# SERVICE SLANTS

SUBJECT: Model 1700 Latch Switch Wiring Change

FIGURE - 1

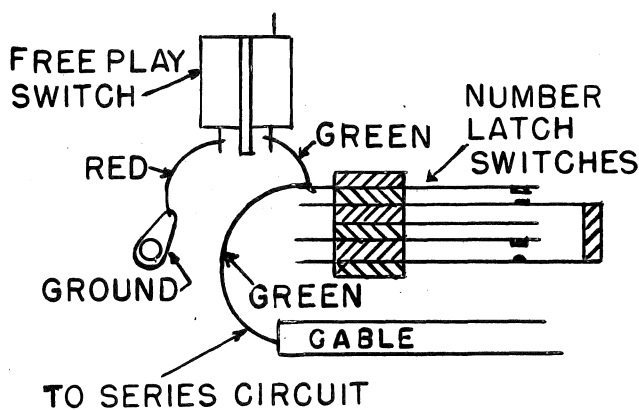
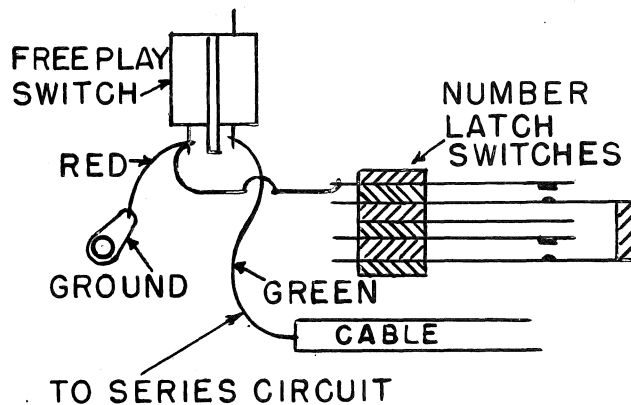
1. The "Number Latch Switch Blade" which connects to the "Normally Open" Free Play Switch Lug may be disconnected from the Free Play Switch and connected to a convenient ground lug or to the common lug of the free play switch (which is already grounded).

2. The Series Circuit Wire which is connected to the "Number Latch Switch Blade" designated in par. 1, will be disconnected from that blade and connected to the "Normally Open Free Play Switch Lug" designated in par. 1.

3. Figures 1 and 2 represent the physical position of wires before and after the changes.
4. The operation of the phonograph is modified as follows:
  - a. Free play at the phonograph may be had by pushing the free-play switch once, and then making selection.

- b. Under these conditions the free play will be recorded on the counter.
  - c. The free play will not be recorded on the counter if the free play switch is held down during the selection cycle and until the record carrier starts to search.
